Access Compliance Report

Public Rights-of-Way

Intersection ID: 2897	Main Street: BELL'S_MILL_DR	Cross Street: HARBURN_FOREST_DR	Location: NW
ADA ID: D937F2BA3ACE	Ramp Type: PerpDiag	Initial Pass/Fail: Fail	Overall Compliance: No
		Severity Score: 37.5

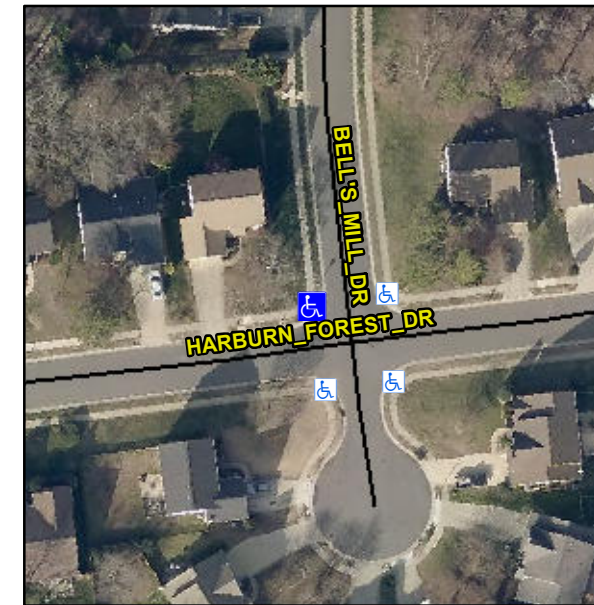
Not Found, R304.2.2, R304.5.3

Compliance	Description	Data	Compliance	Description	Data
N/A	Ramp Length (in)	48.0	No	Ramp Slope (%)	11.5
Yes	Ramp Width (in)	144.0	No	Ramp XSlope (%)	8.5
N/A	Flare Type LT	N/A	N/A	Flare Type RT	N/A
N/A	Flare Slope LT (%)	N/A	N/A	Flare Slope RT (%)	N/A
N/A	Flare Traversable LT?	N/A	N/A	Flare Traversable RT?	N/A
N/A	Landing Length (in)	N/A	N/A	DWS Provided?	N/A
N/A	Landing Width (in)	N/A	N/A	DWS Contrast?	N/A
N/A	Landing Slope (%)	N/A	N/A	DWS Length (in)	N/A
N/A	Landing X Slope (%)	N/A	N/A	DWS Full Width?	N/A
N/A	Landing Curb? (Y/N)	N/A	N/A	DWS Offset (in)	N/A
N/A	Shared Landing?	N/A			
N/A	Gutter Ponding?	N/A	N/A	Gutter Slope (%)	N/A
N/A	Gutter Lip Ht (in)	N/A	N/A	Gutter X Slope (%)	N/A
N/A	Painted X Walk1?	No	N/A	Painted X Walk2?	No
	X Walk 1 Direction	To S		X Walk 2 Direction	To E
N/A	X Walk 1 Width (in)	N/A	N/A	X Walk 2 Width (in)	N/A
	X Walk 1 Slope (%)	8.5		X Walk 2 Slope (%)	0.1
	X Walk 1 X Slope (%)	3.3		X Walk 2 X Slope (%)	6.9

Remove & Replace Curb Ramp With Two New Directional Ramps or Equivalent.
